RECEIPT DATE: 1/7/21 **ONSITE SEWAGE DISPOSAL SYSTEM** P 572914

APPROVAL DATE: 1/19/21 (ST) **PERMIT:** **REPAIR** A _____

PROPERTY ADDRESS: 3663 Jennings Chapel Road

NOT TO SCALE

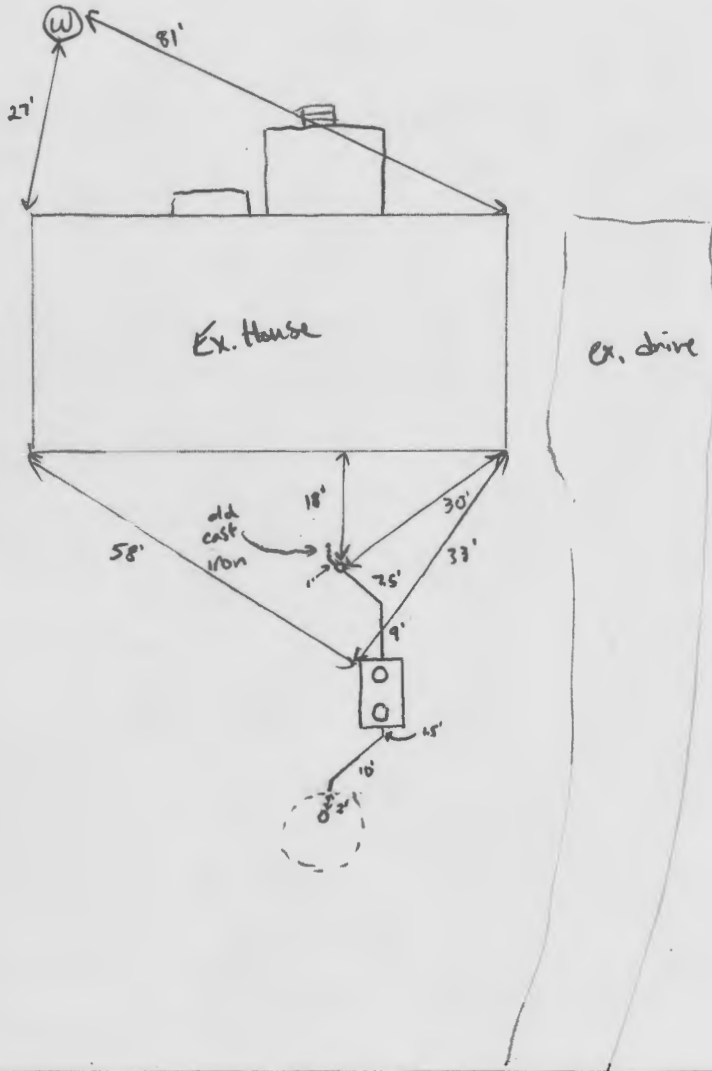
01/15/2021 MOVED NEW TANK LOCATION BTWN EXISTING AND DW TO MANAGE COVER AND NOT IMPACT BX TRENCH. EX DW IS COMPLETELY DRY. MAKE SURE TANK DELIVERY DOES NOT GO OVER DRY WELL. (H)

1/19/2021 New 1500 gal septic tank installed and connected via ferroc to old cast iron line coming out of the house. Connected into existing drywell. (SI)

Picture 3:

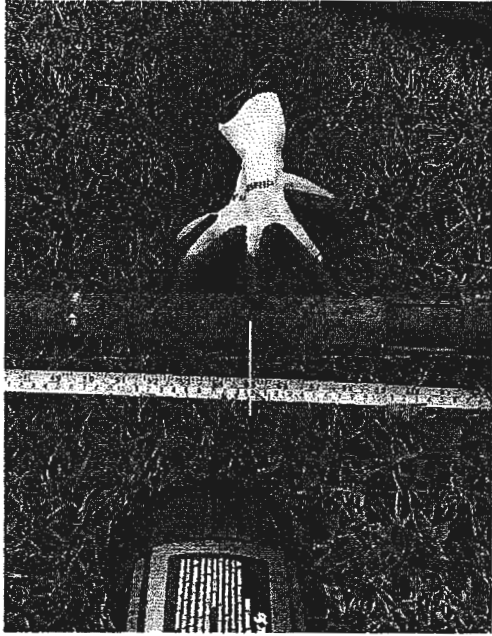
Picture shows the effluent level in the tank has receded 6 inches after being returned to a normal operating level the day of the original inspection, indicating the tank is leaking.
